Item Name: Fwd Crosstube - Mid Height 206L / L1 / L3 / L4, Blue

DART AEROSPACE LTD HAWKESBURY, ONTARIO, CANADA	
DRAWING NO. D206-667-147	REV. A SHEET 1 OF 4
TITLE CROSSTUBE ASS'Y (206L MID FWD)	SCALE NTS

DRAWING NO. D206-667-147	TITLE CROSSTUBE ASS'Y (206L MID FWD)	REV. A	DART AEROSPACE LTD ENGINEERING ORDER		D.E.O. NO. D206-667-147-A-1	SHEET NO. SHEET 1 OF 1	SCALE NTS
DRAWN <i>q</i>	CHECKED <i>ASS</i>	MFG. APPR. <i>JB</i>	APPROVED <i>MD</i>		DE APPR. <i>MD</i>		
DATE 11.07.15	DATE 11.07.20	DATE 11.07.21	DATE 11/07/21		DATE 11.07.21

DRAWING NO. D206-667-147	TITLE CROSSTUBE ASS'Y (206L MID FWD)	REV. A	DART AEROSPACE LTD ENGINEERING ORDER	D.E.O. NO. D206-667-147-A-2	SHEET NO. SHEET 1 OF 1	SCALE NTS
DRAWN AJS	CHECKED	MFG. APPR.	APPROVED	DE APPR.		
DATE 12.08.02	DATE 12.08.02	DATE 12.08.02	DATE 12.08.02	DATE 12.08.02	DATE 12.08.02

DETAIL P
BONDING STRAP INSTALLATION 2 PL

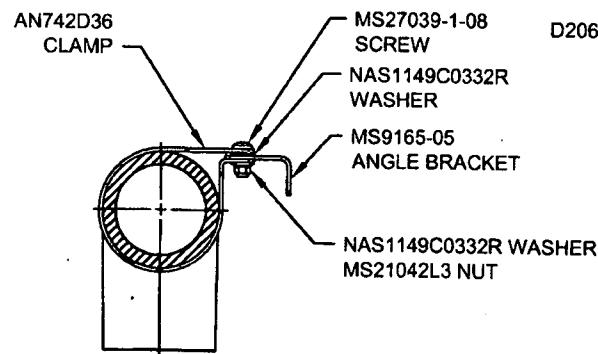
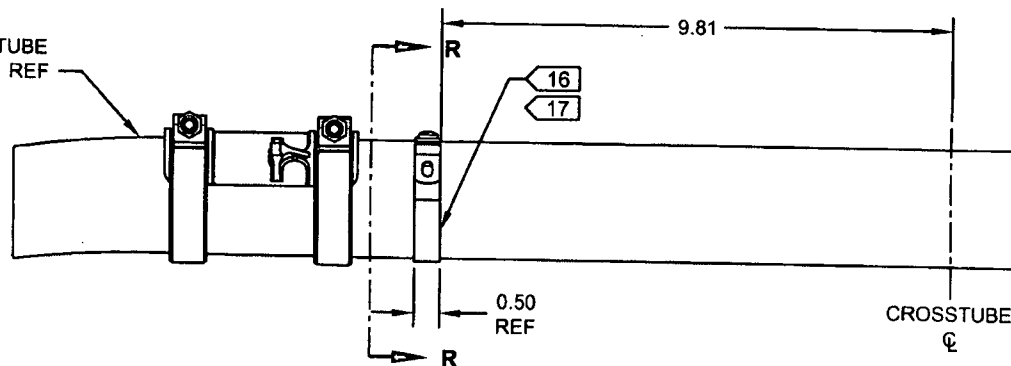
ADD ELECTRICAL GROUNDING STRAP

- 16) MASK AREA UNDER CLAMP PRIOR TO PAINTING
- 17) SEAL EDGES WHERE AN742D36 CLAMP MEETS WITH THE CROSSTUBE USING SIKAFLEX-241/-291 OR MIL-S-8802 CLASS B2 OR PROSEAL 890 SEALANT
- 18) PERFORM RESISTANCE CHECK TO ENSURE MAX RESISTANCE IS 10 MILLIOHMS

ITEM	QTY -147	PART NUMBER	DESCRIPTION
1	X	D206-667-147	CROSSTUBE ASSEMBLY (206L MID FWD)
10	2	AN742D36	CLAMP
11	2	MS9165-05	ANGLE BRACKET
12	2	MS21042L3	NUT (OR MS21042-3)
13	2	MS27039-1-08	SCREW
14	4	NAS1149C0332R	WASHER (OR AN960C10L)
